**Planning Application Ref:** AB/88/19/PL

**Location:** Land at Electricity Sub Station, Ford Road, Arundel, BN18 9DX

**Description of works:** 38no. residential apartments (9 No 1-bed units & 29 No. 2-bed units) along with access, off-street parking, amenity space & enhancements to the local footpath network

# Land at rear of 1-9 Ford Road, Arundel, BN18 9DX

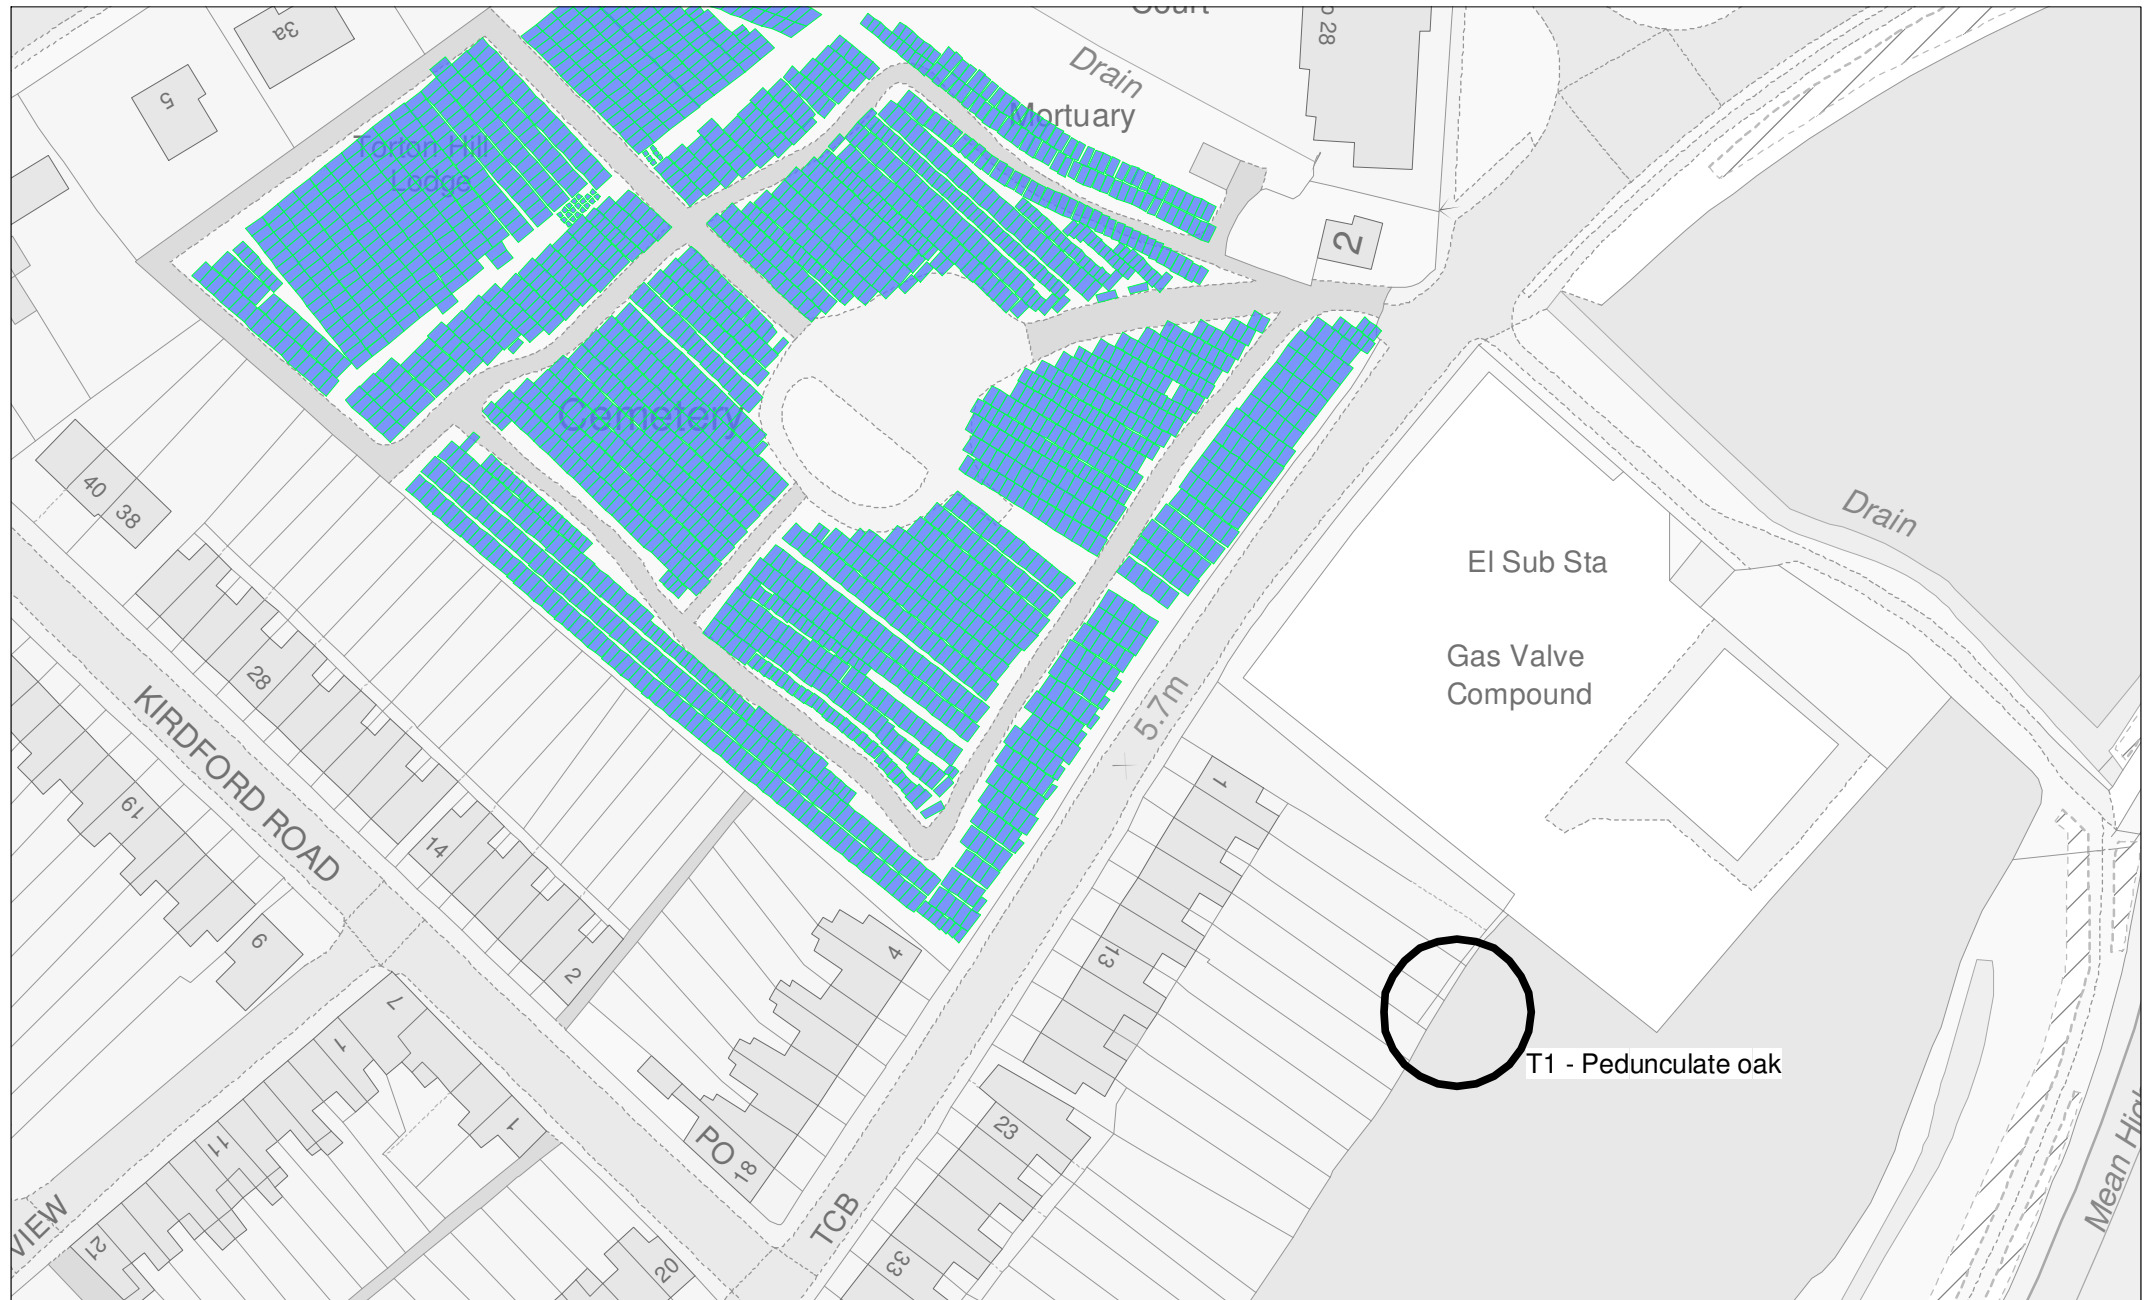
- **I recommend the making of a Tree Preservation Order** in respect of off-site pedunculate oak T8 to control transition to veteran tree status and secure its place in the landscape. I attach a TEMPO form and GIS plan for this purpose.
